PLANNING COMMISSION MEETING

LOCATION: TOWNSHIP ANNEX, 7527 HIGHLAND ROAD, WHITE LAKE, MI 48383
THURSDAY, APRIL 17, 2025 – 6:30 PM

RE: White Lake Motors - Preliminary Site Plan Review, Final Site Plan and Final Engineering Review- 3rd Review

Combined Preliminary – Final Site Plan / Special Land Use Review for White Lake Charter Township, Michigan

SHEET
SP2.1

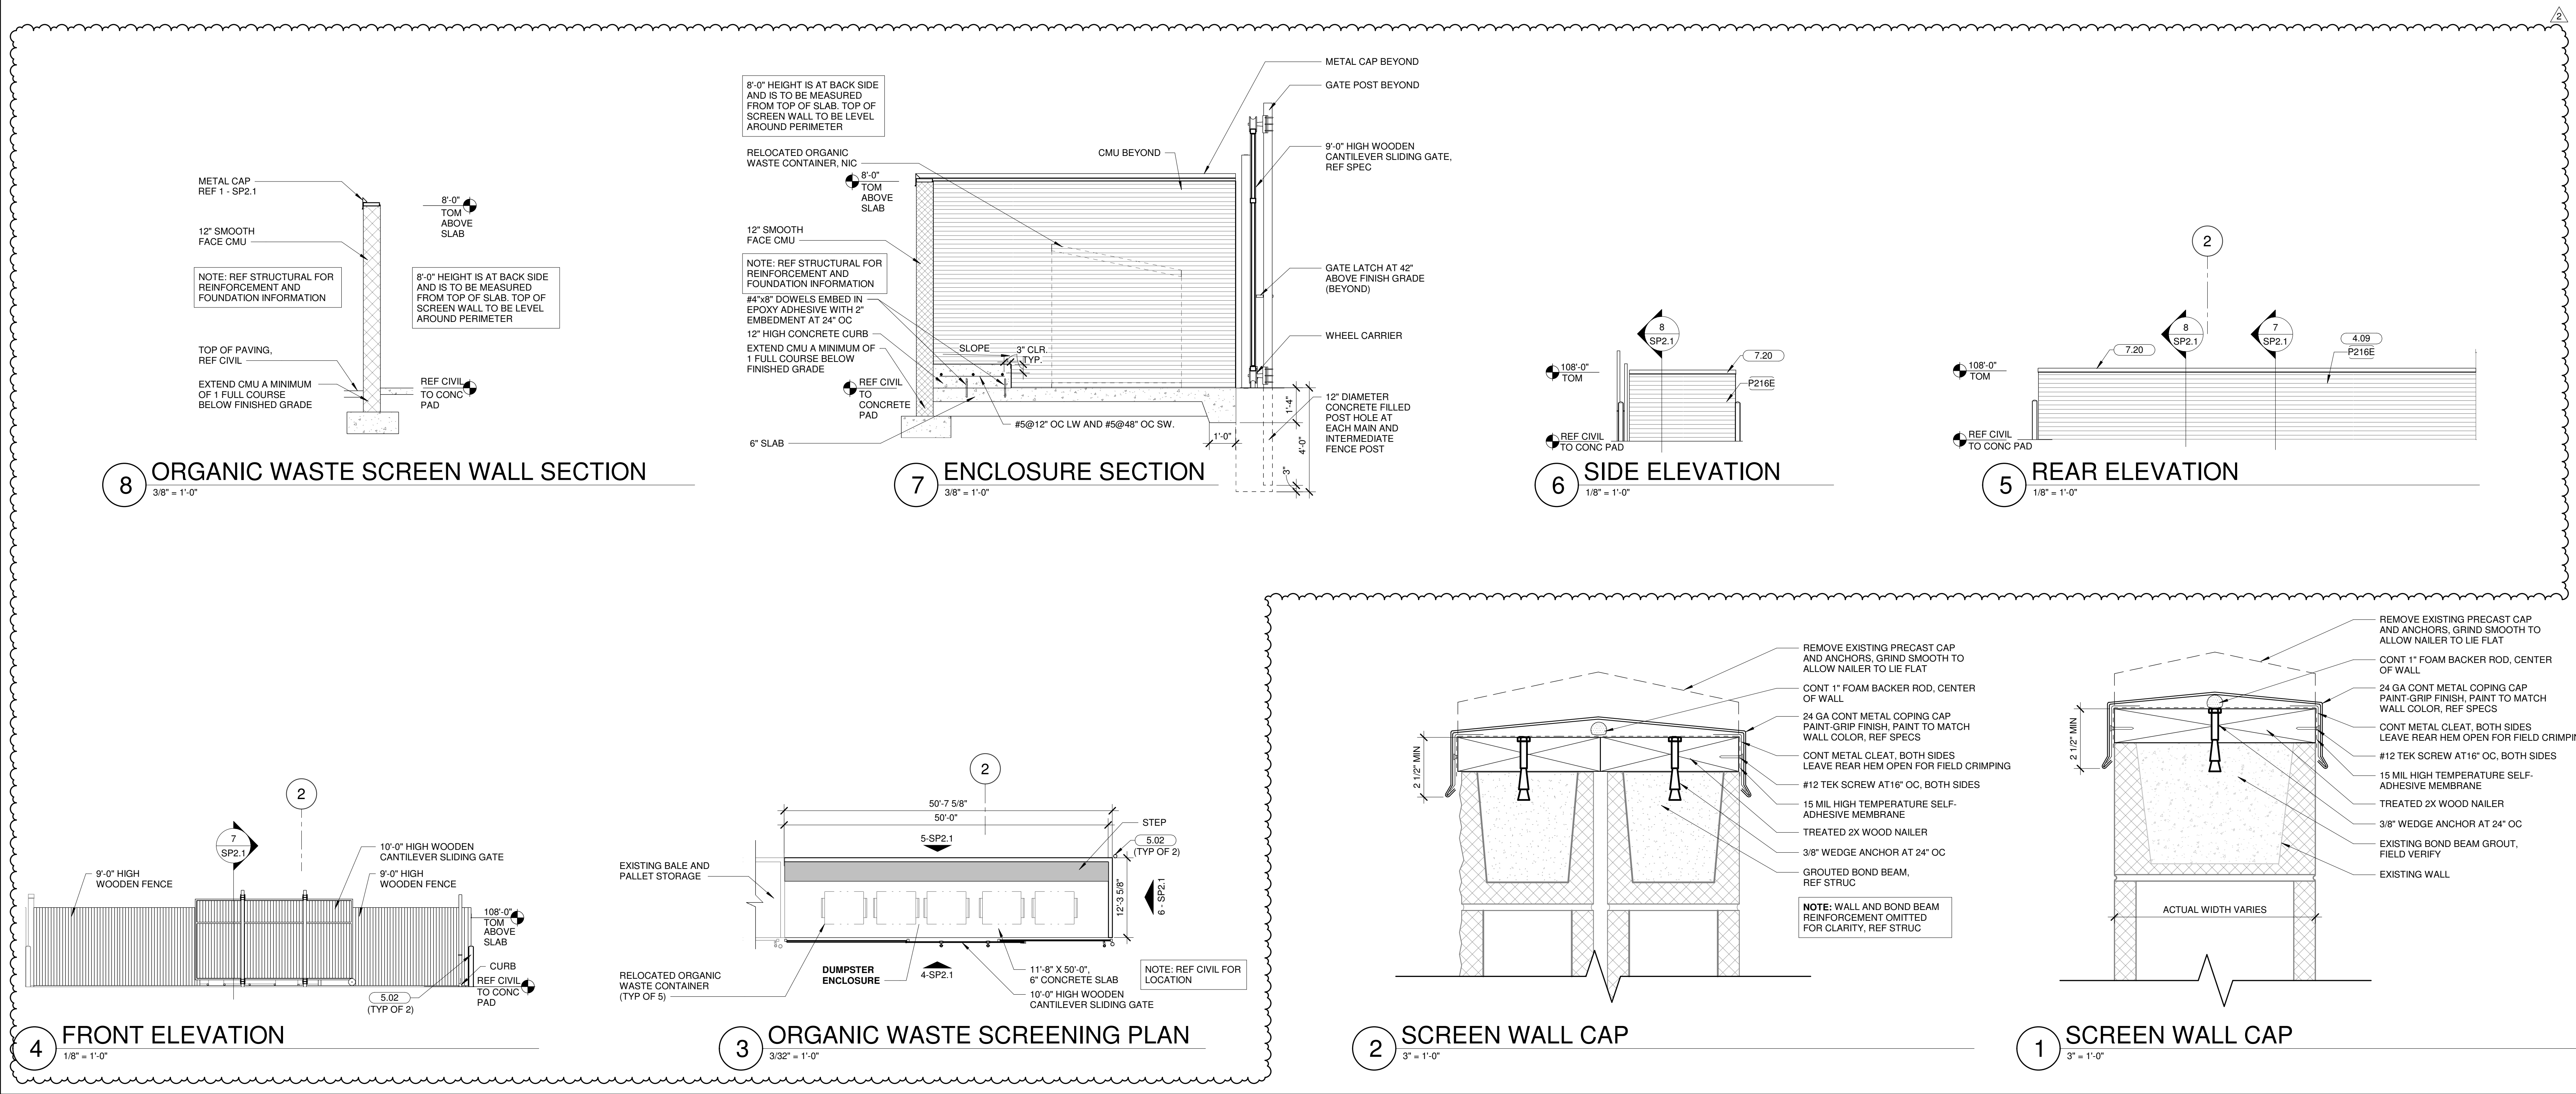
- c. Sheet SP1- Remove 'Relocated Existing Trash Dumpster (Typ of 3)' note on west side of building.
 - d. Sheet SP2.1- 3 Organic Waste Screening Plan- remove note 'Note: Ref Civil for location.' Location of dumpsters is shown on architectural plan Sheet C1 and not on the civil plan sheets.

SHEET: S5

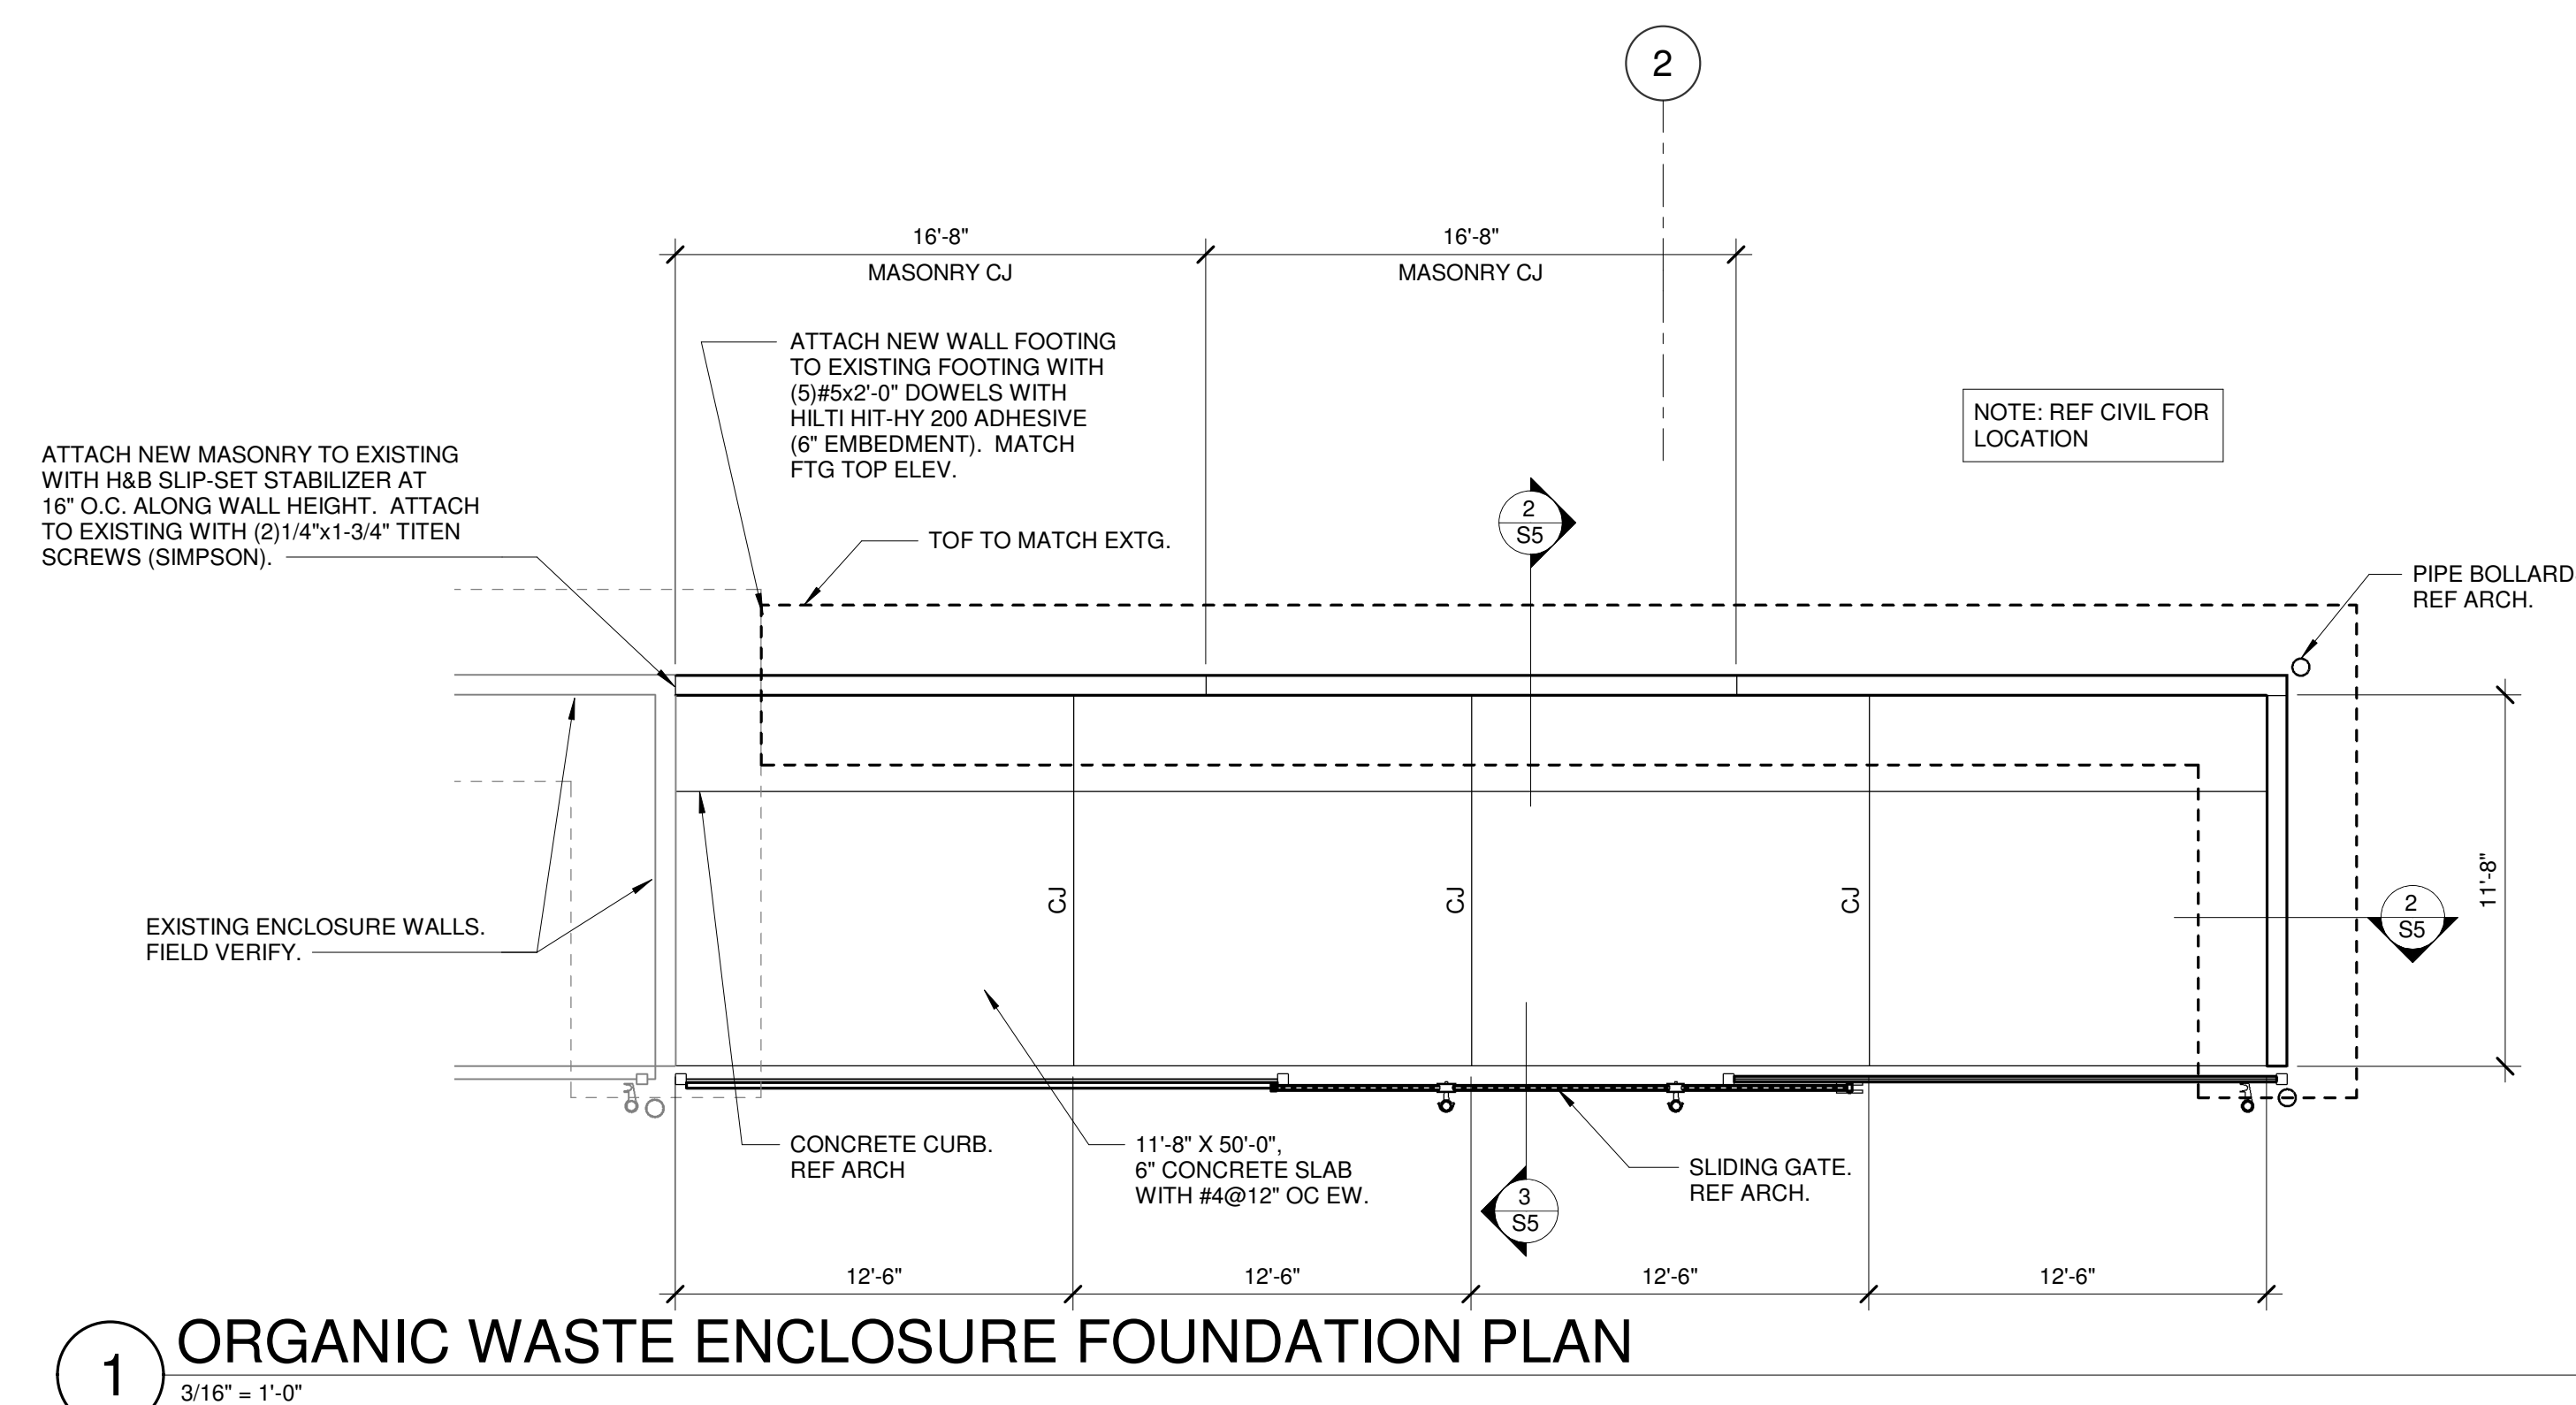
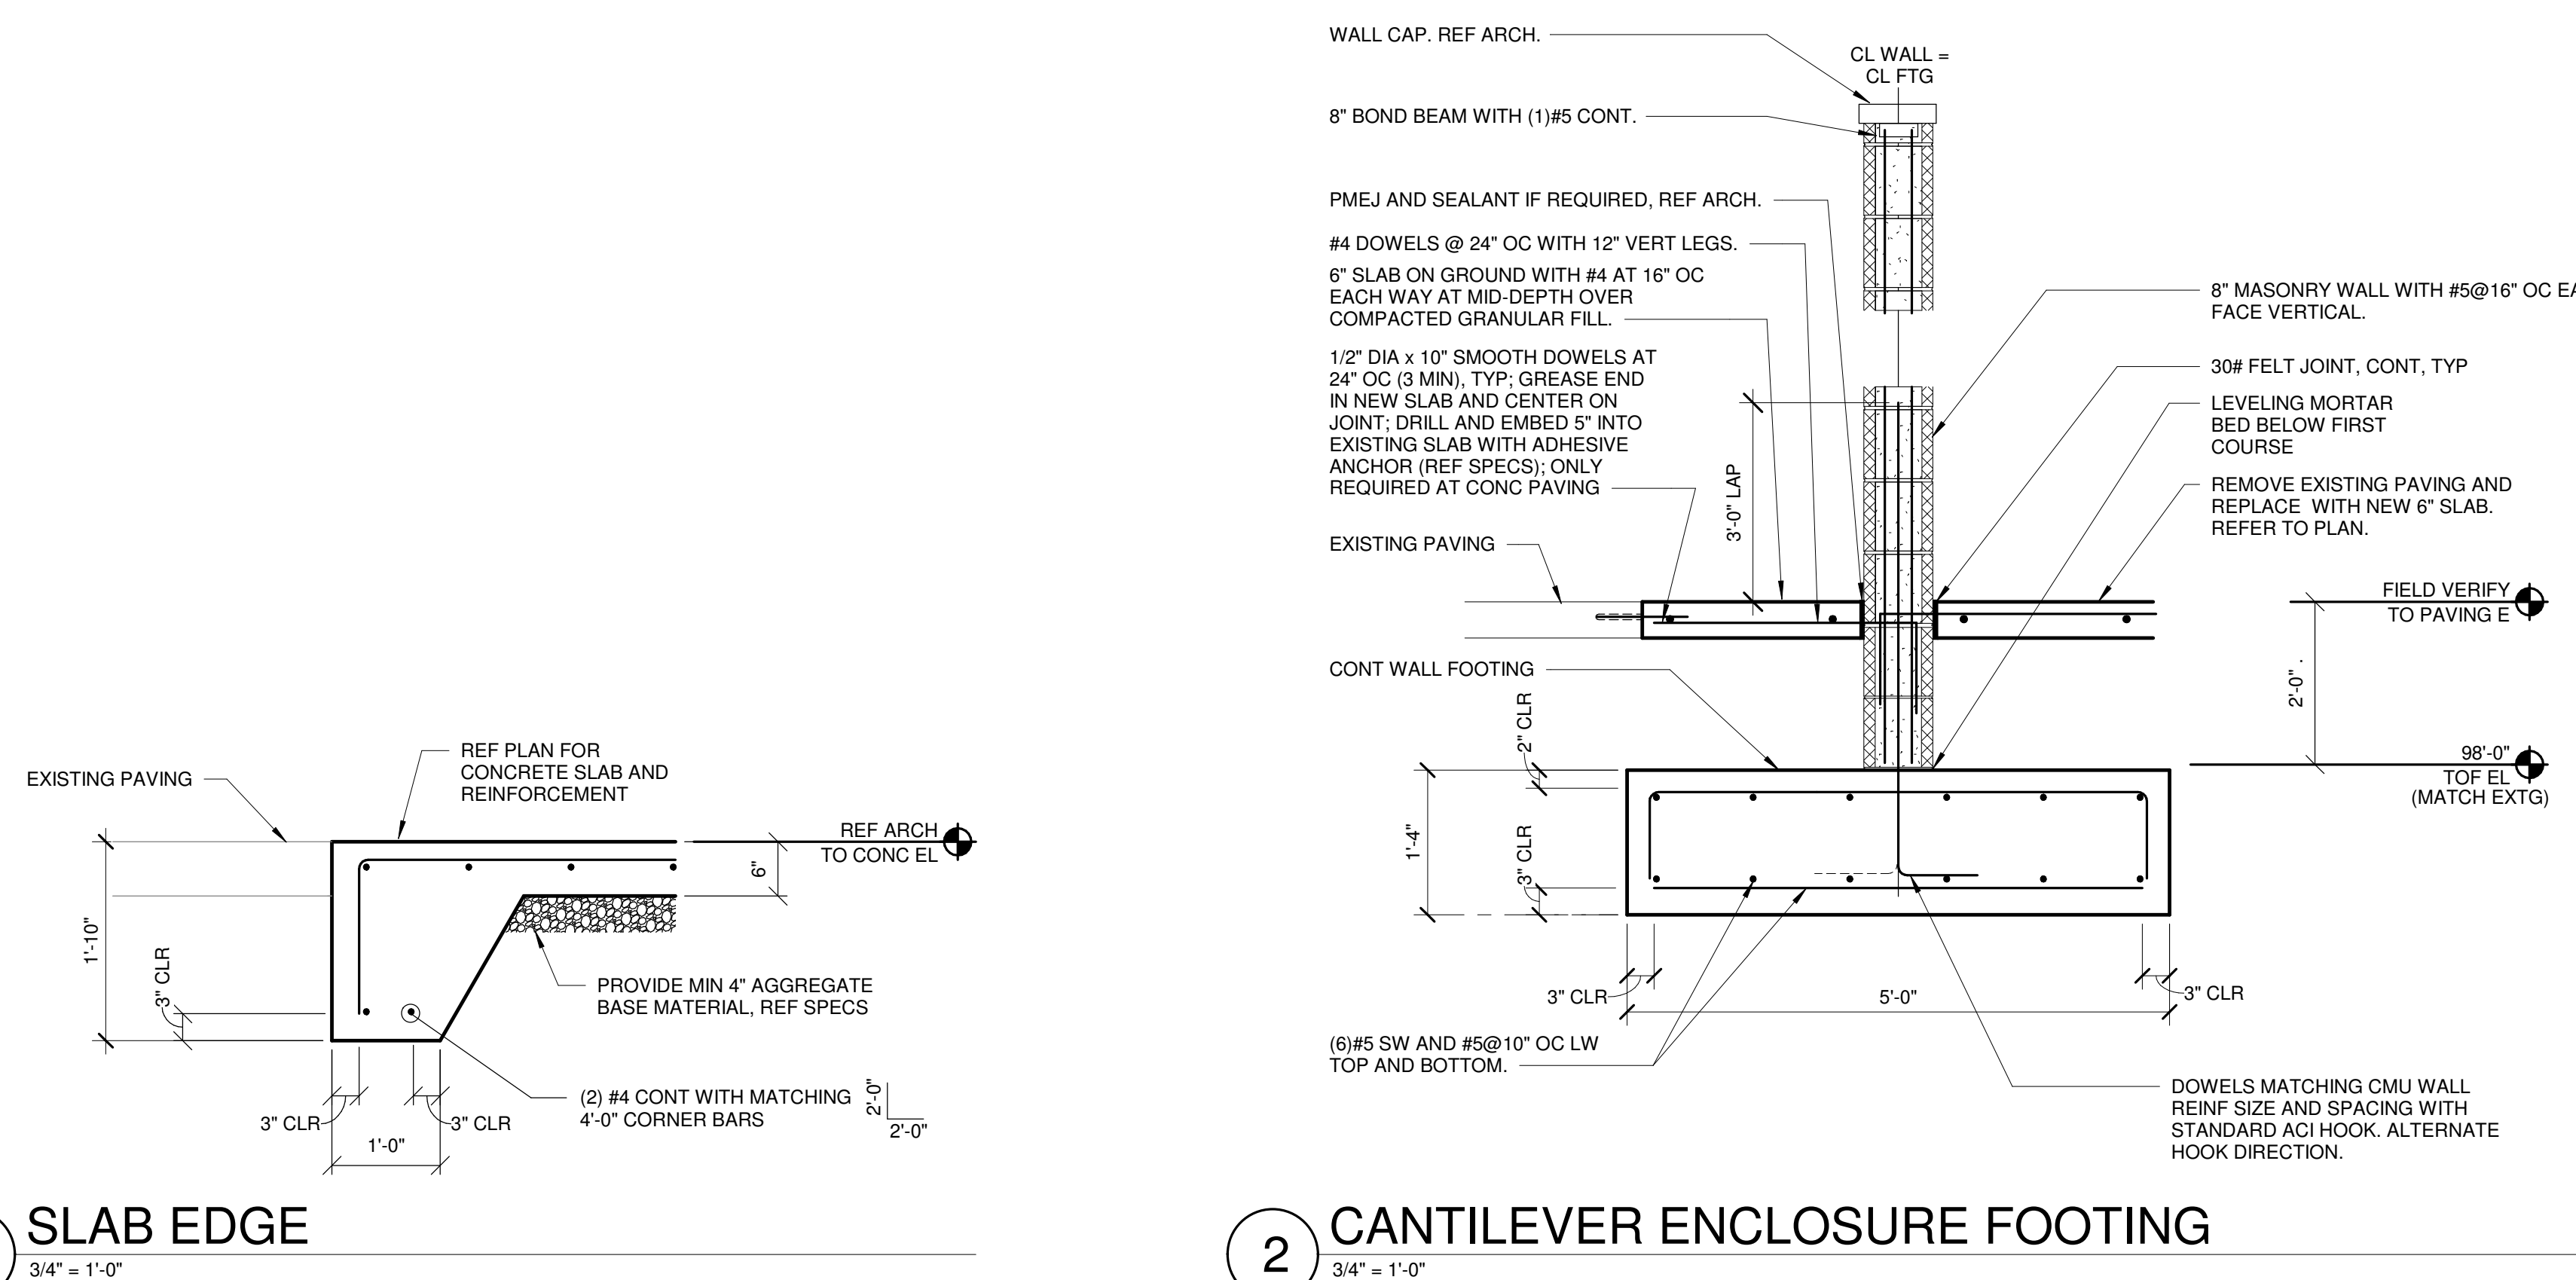
- e. Sheet S5- 1 Organic Waste Enclosure Foundation Plan- remove note 'Note: Ref Civil for location.' Location of enclosure is shown on architectural plan Sheet C1 and not on the civil plan sheets.
